Access Compliance Report

Public Rights-of-Way

Intersection ID: 10014590	Main Street: GRIER_SPRINGS_LN	Cross Street: N/A	Location: N
ADA ID: C66089A2174B	Ramp Type: PerpDiag	Initial Pass/Fail: Fail	Overall Compliance: No
Severity Score: 18.75			
Codes/Mitigation Info/Possible Solution		Field Measurements/Component Compliance

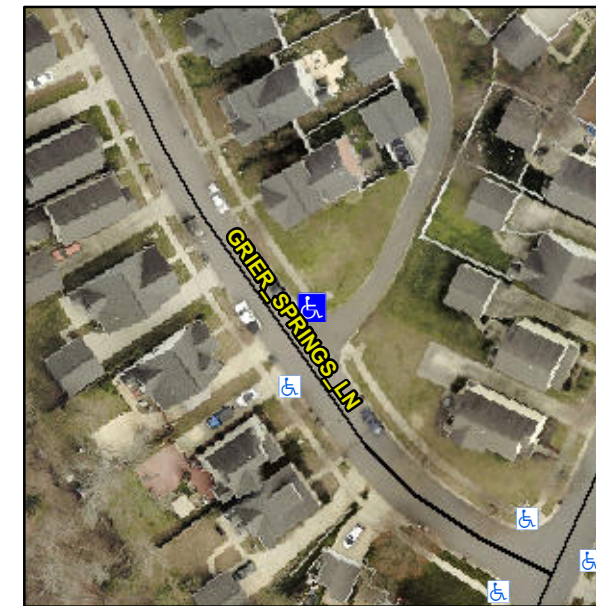
Not Found, R304.5.1

Compliance	Description	Data	Compliance	Description	Data
N/A	Ramp Length (in)	64.0	Yes	Ramp Slope (%)	5.7
No	Ramp Width (in)	34.0	Yes	Ramp XSlope (%)	4.4
N/A	Flare Type LT	N/A	N/A	Flare Type RT	N/A
N/A	Flare Slope LT (%)	N/A	N/A	Flare Slope RT (%)	N/A
N/A	Flare Traversable LT?	N/A	N/A	Flare Traversable RT?	N/A
N/A	Landing Length (in)	N/A	N/A	DWS Provided?	N/A
N/A	Landing Width (in)	N/A	N/A	DWS Contrast?	N/A
N/A	Landing Slope (%)	N/A	N/A	DWS Length (in)	N/A
N/A	Landing X Slope (%)	N/A	N/A	DWS Full Width?	N/A
N/A	Landing Curb? (Y/N)	N/A	N/A	DWS Offset (in)	N/A
N/A	Shared Landing?	N/A			
N/A	Gutter Ponding?	N/A	N/A	Gutter Slope (%)	N/A
N/A	Gutter Lip Ht (in)	N/A	N/A	Gutter X Slope (%)	N/A
N/A	Painted X Walk1?	No	N/A	Painted X Walk2?	No
	X Walk 1 Direction	To W		X Walk 2 Direction	To S
N/A	X Walk 1 Width (in)	N/A	N/A	X Walk 2 Width (in)	N/A
	X Walk 1 Slope (%)	4.0		X Walk 2 Slope (%)	5.8
	X Walk 1 X Slope (%)	8.8		X Walk 2 X Slope (%)	4.4

Remove & Replace Curb Ramp With Two New Directional Ramps or Equivalent.
